AP1000 Draft Safety Evaluation Report LBB Open Items

**Presentation to NRC Staff
Rockville, MD**

July 11, 2003

AP1000 Draft Safety Evaluation Report

Figure 8.6.1 AP1000 Bounding Analysis Curve for 8" CMT DVI IRWST
(Line Numbers: L015A, 016A, 016A, 020A, 021A-No Insul., 025A, 125A, 127A)

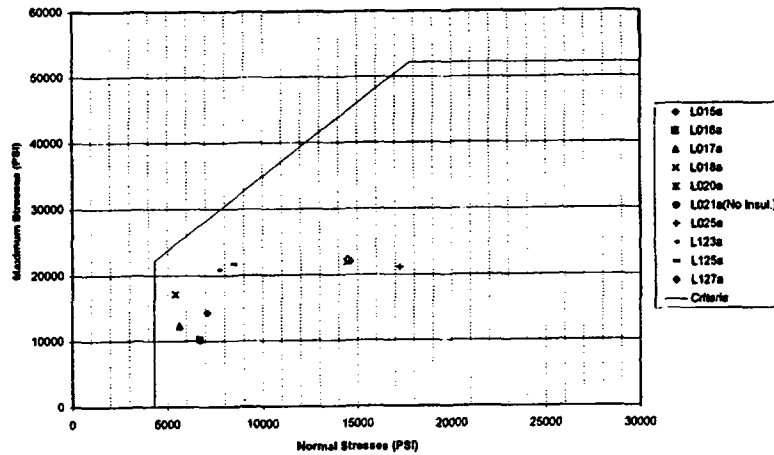
- **Piping stress analysis for AP1000 candidate system in-progress**
- **DVI-A Piping Analysis Package**
 - Selected based on our experience with AP600
 - Difficult to qualify
 - Complicated piping system
 - Some piping sizes were changed
 - Contains smallest piping line qualified for LBB
 - Subcompartment pressurization impacts if line would not meet LBB criteria

- **SECY-02-0059 Approved DAC Approach for Piping**
 - Design Acceptance Criteria in lieu of detailed piping design and analysis
- **W approach specifies that piping stress analysis be completed as part of COL application**
- **AP600 piping stress analyses can be used to demonstrate feasibility for AP1000**
- **AP1000 piping stress analysis for DVI-A further demonstrates feasibility**
- **No additional piping analysis required**

Figure 9.5.3 AP1000 Bounding Analysis Curve for RNS Discharge
(Line Number: L019A)

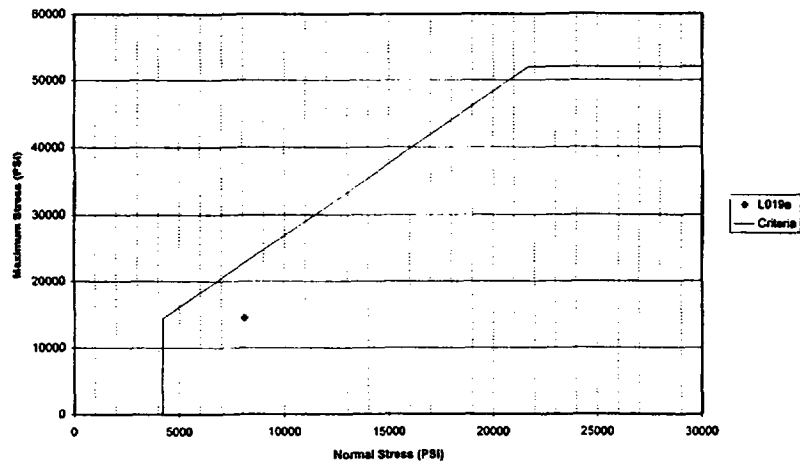
- Identifies TGSCC as a possible failure mechanism for AP1000 piping systems
- If TGSCC crack morphology parameters are assumed, LBB bounding curves would be impacted, and it will be more difficult to demonstrate that AP1000 piping systems meet LBB
- Requests W to perform piping stress analysis and perform sensitivity analysis for 5 piping systems to demonstrate that AP1000 piping systems can meet LBB
